# Certificate of Appropriateness

<b>Property</b>	<b>2912 E. BELLEVIEW PL. North Point North Historic District</b>
<b>Description of work</b>	Restore two window openings per the original drawings. Remove existing non-original kitchen window on the east elevation and replace in same opening with a 3-bay casement window made of wood to match the existing wood, zinc and glass windows on the house. Remove a non-original second story window on the north elevation in the gable and replace it with a wood casement window to match the other divided lite windows on the house. Replace rear entry door and storm with new wood door and storm.
<b>Date issued</b>	7/3/2013 PTS ID 88429 COA, window change out

### East Elevation.

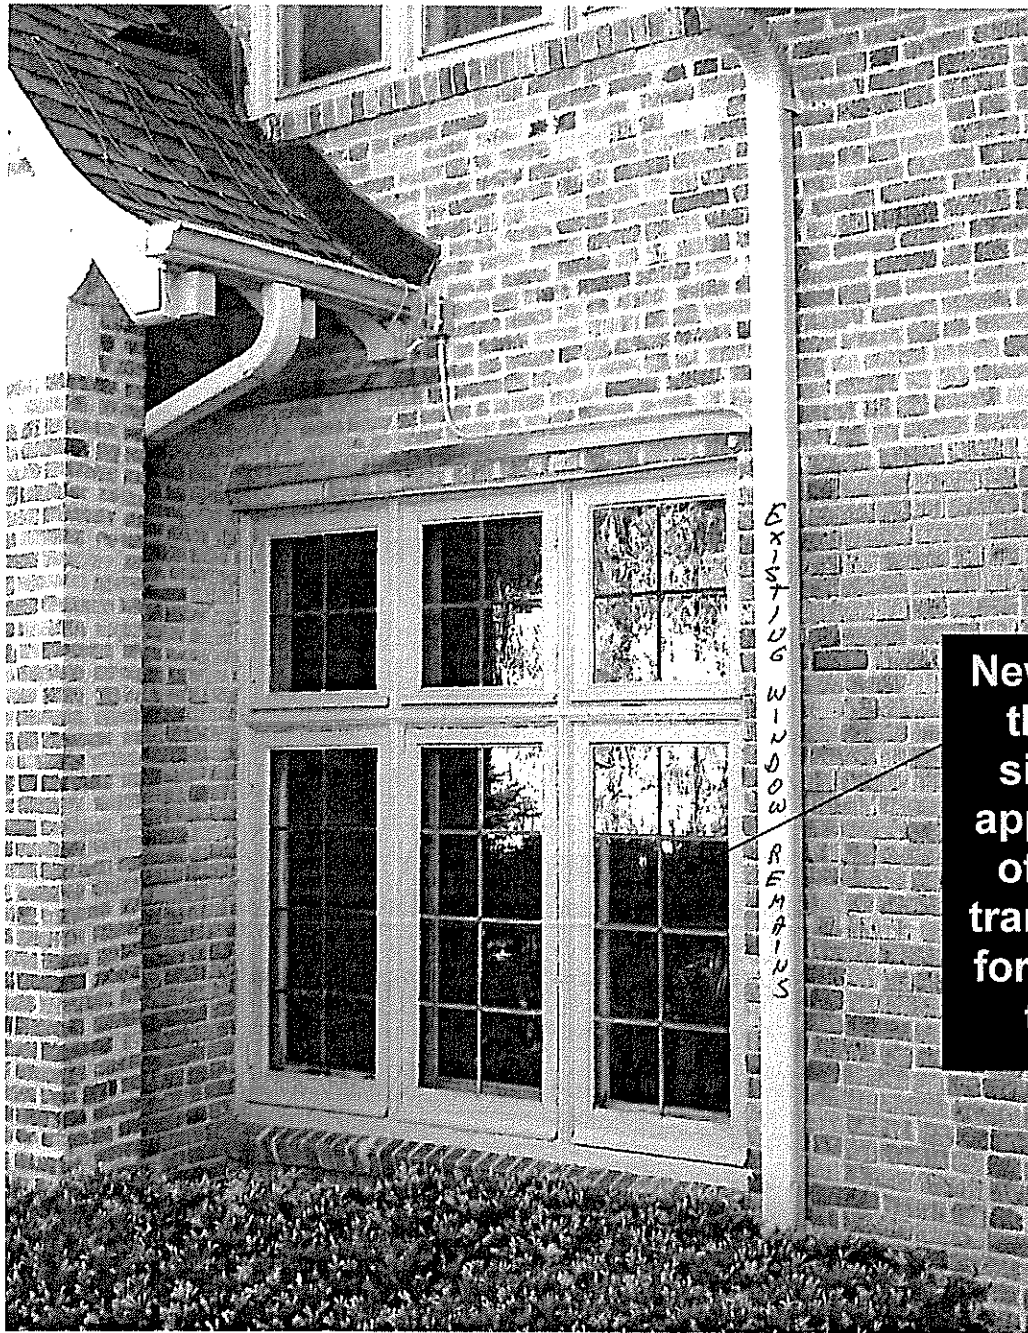
Existing wood window, jambs and sill will be completely removed. The opening will then be fitted with a new all-wood casement window to match the original casement windows on the house. If original brick sill remains, it will re-used. If not a new stone sill to match the existing stone on the house will be installed and must two courses of brick in height.

Alternatively a new brick sill can be installed provided the new brick match in color, texture and size and the mortar matches the original in terms of color, texture, hardness, joint width and joint finish.

EXISTING WINDOW REMAINS

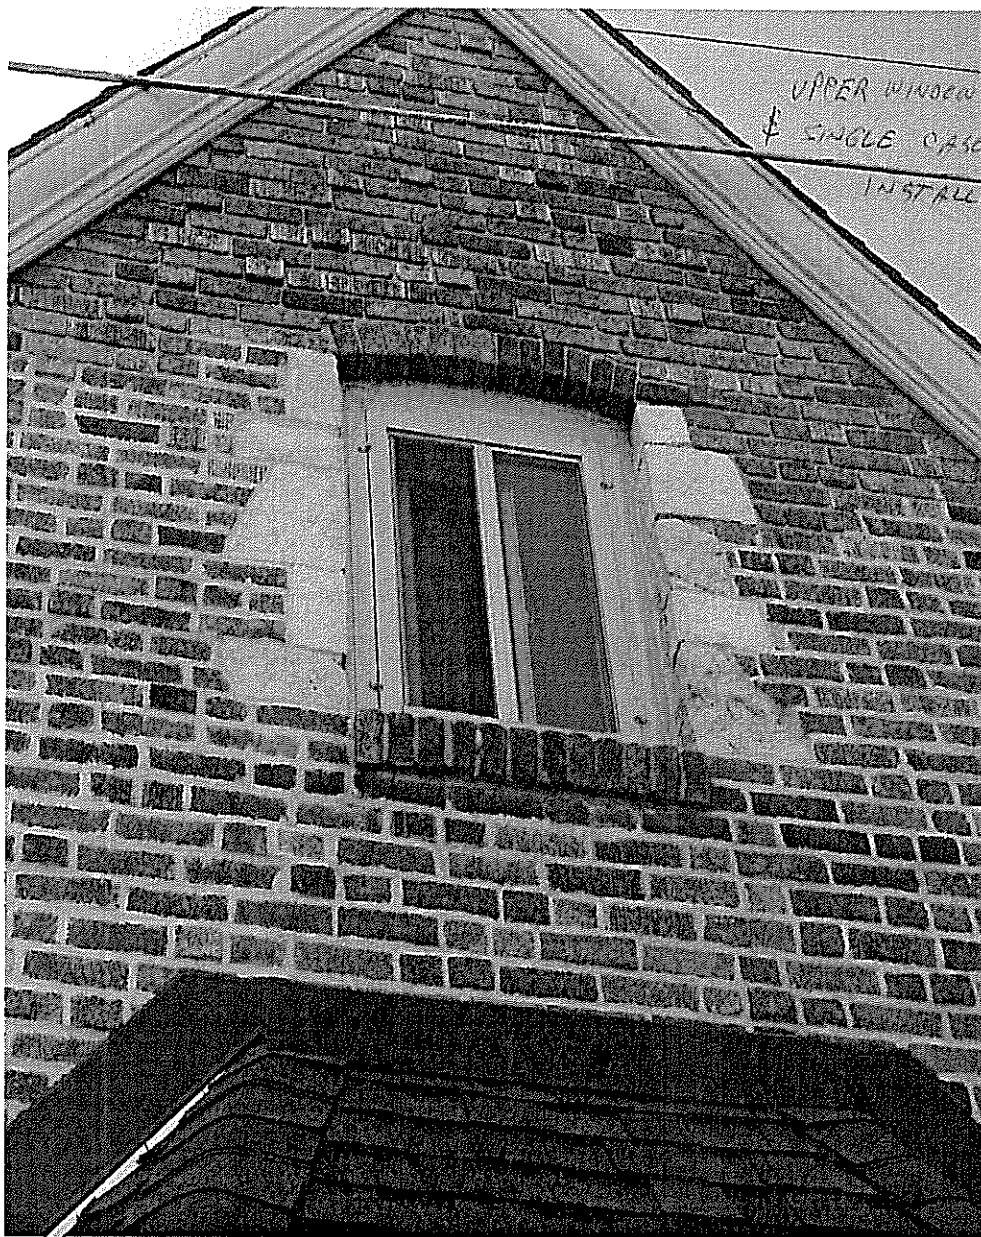
**New window will match these windows with simulated zinc came applied to the outsides of the windows. The transom will be omitted for the new kitchen per the original plans.**

**North elevation.**

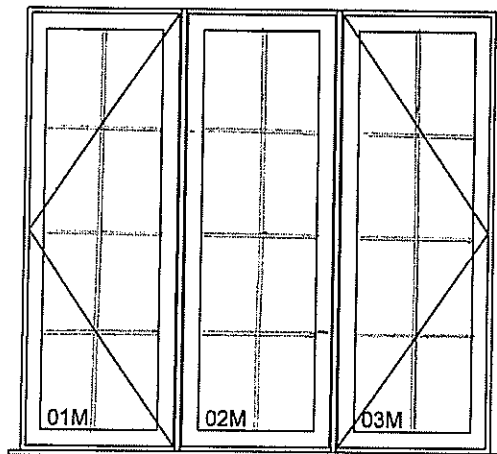
**Remove existing non-original window and replace it with a divided lite wood casement window to match the originals.**

**Design of new all wood  
casement window for  
second story, north  
elevation gable.**

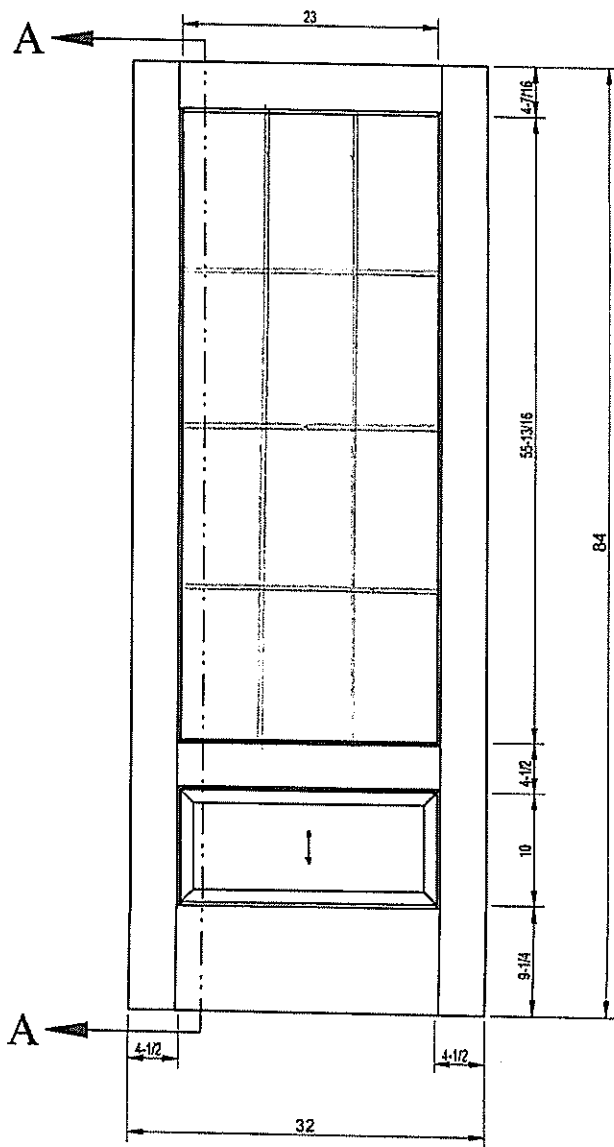
UPPER WINDOW  
REPLACED TO RESTORE  
ORIGINAL APPEARANCE  
W/ SINGLE PANE WINDOW &  
LEAD GLASS MULLIONS  
(STAINED GLASS OVERLAY)
